29 January 2025

Addendum 4

**Columbus County
Sheriff's Department
Whiteville, NC**

EXISTING CONDITIONS AND
DEMOLITION PLAN

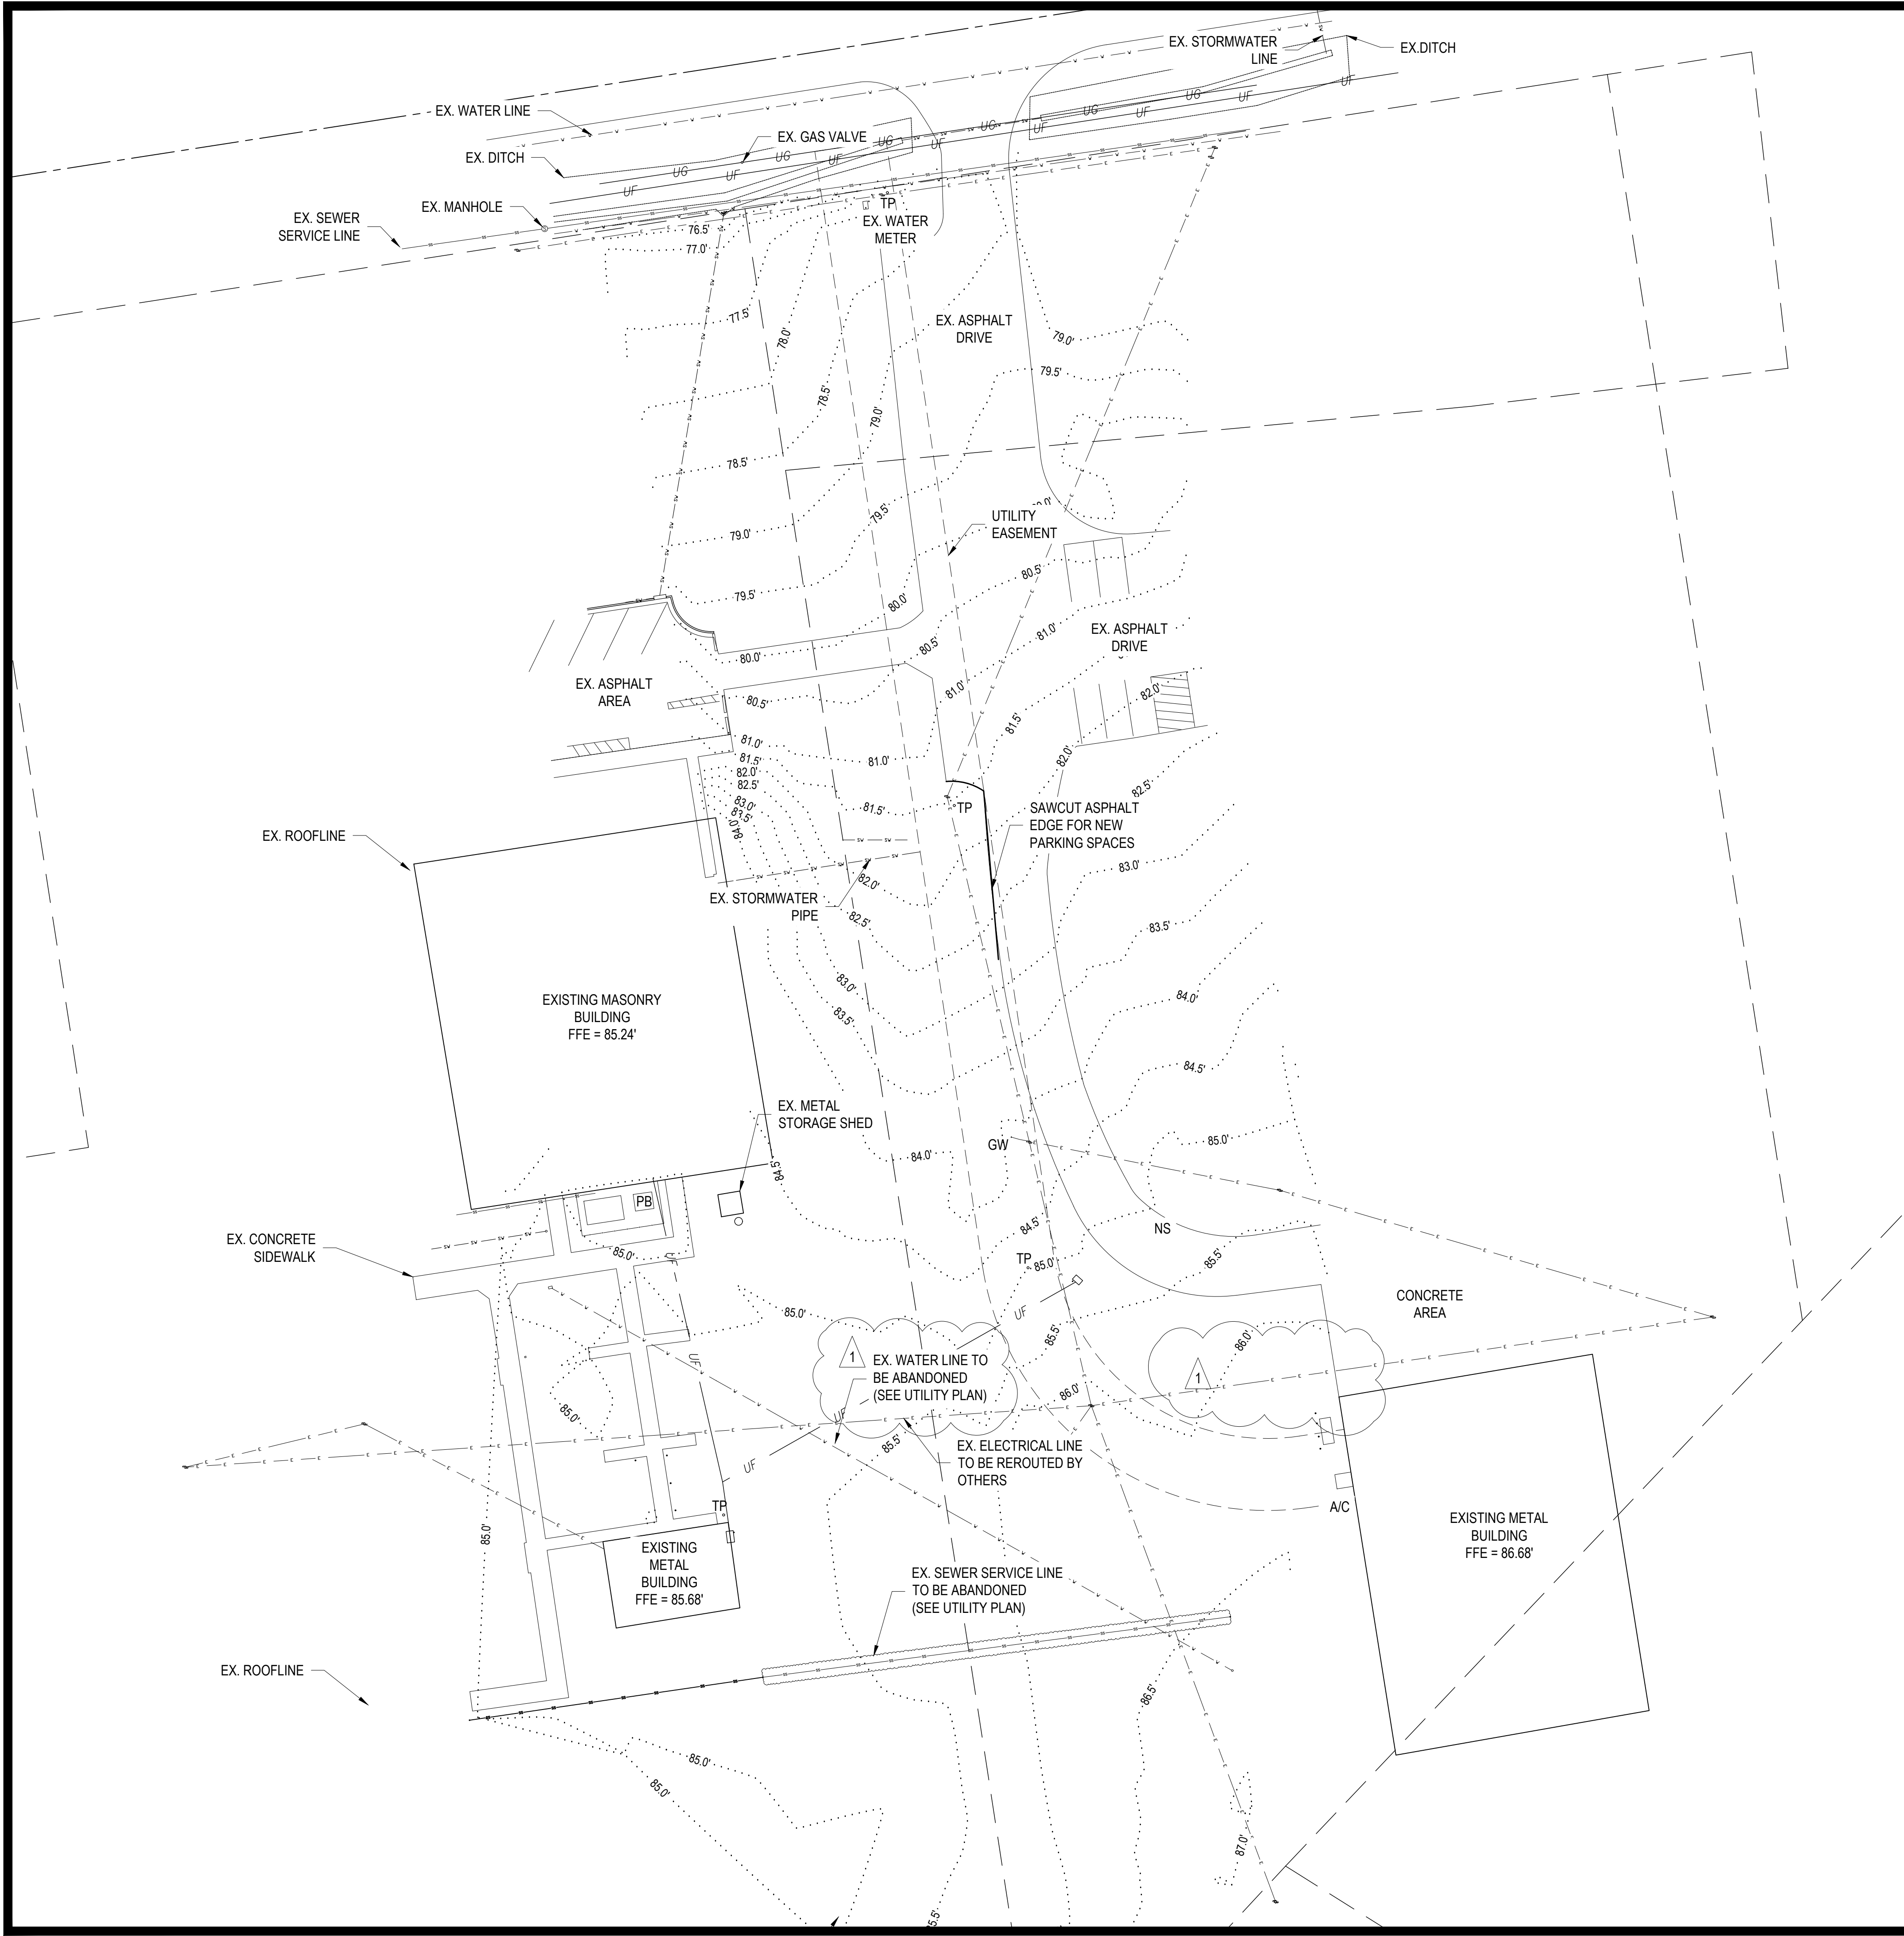
- See revised Sheets C-1 and C-3 clarifying the RPZ detail, water and sewer connections. Provide receptacle in hot box for heat trace, run to 20 amp spare breaker in closest electrical panel
- Increase Brick allowance from \$550/thousand to \$850/thousand (materials only)
- Clarification: Sheet FA2: in the Connecting Corridor, the RAP devices shown are Remote Annunciator Panels
